**Re: Yukon Energy Corporation (Yukon Energy or YEC) Submission for the referral of the Electricity Purchase Agreement (EPA) with Tlingit Homeland Energy LP (THELP) to the Yukon Utilities Board (Board) for review under s. 18(1) of the Public Utilities Act – Amended and Restated EPA**

### **Summary of Key Changes to EPA**

**Figure 1: Amended EPA: Project Hydro Generation Components**

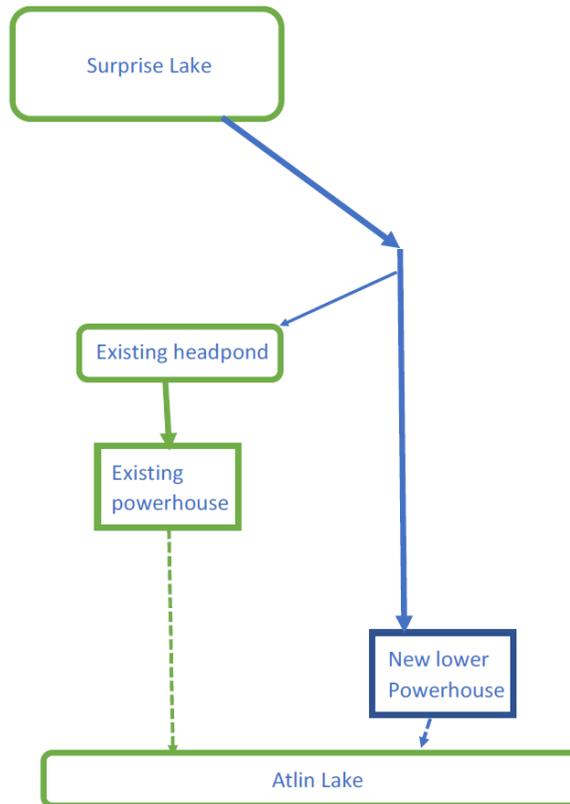
Key changes proposed by Dent to the Project configuration included one versus two powerhouses supplied by a penstock versus a power canal; and a single target commercial operation date (Target COD) at December 1, 2024 rather than Phase One and Phase Two Target CODs during October 2024. THELP advised Yukon Energy that the change to a penstock to replace the power canal was also desired to address environmental review concerns with the power canal raised by regulators in BC.

- **One Powerhouse vs Two** – The new powerhouse is located at the previous Lower Powerhouse site, as shown in Figure 1. The following changes in related capacity and long-term average (LTA) Delivered Energy at Jakes Corner Point of Interconnection (POI) are noted:

- Installed generation capacity at Atlin is increased to 9.3 MW vs 8.7 MW combined for the two powerhouses in the original design;
  - Delivered capacity at Jakes Corner POI is increased to 8.75 MW vs 8.0 MW in the original design; and

- LTA Winter Delivered Energy at POI is increased to 34.0 GWh/yr vs 30.8 GWh/yr with the original design.
- **Penstock from Surprise Lake to Powerhouse - no power canal** – Figure 1 shows in the blue line the 18.8 km penstock to connect the new Surprise Lake Intake Structure to the new Powerhouse. The original design proposed an approximately 7.8 km power canal in a redeveloped abandoned placer mining ditch to connect a new control structure in Pine Creek with a 4.7 km penstock to the Upper Powerhouse located adjacent to the 2.1 MW Existing Plant.

- **Tap to Existing Plant** – A tap from the new Penstock to the Existing Plant will enable the Existing Plant to use this source for its water from Surprise Lake rather than continue to rely upon Pine Creek as the conduit of its water supply. Section 7.3 of the Amended EPA has new provisions to reflect this change in the Project as regards the Existing Plant tap and potential future changes when the current EPA with BC Hydro is renewed.

THELP and Yukon Energy have accordingly agreed to changes to the hydro generation components of the Project as described in Schedule B of the Amended EPA and shown in Figure 1 below. Specific hydro generation plant design changes include:
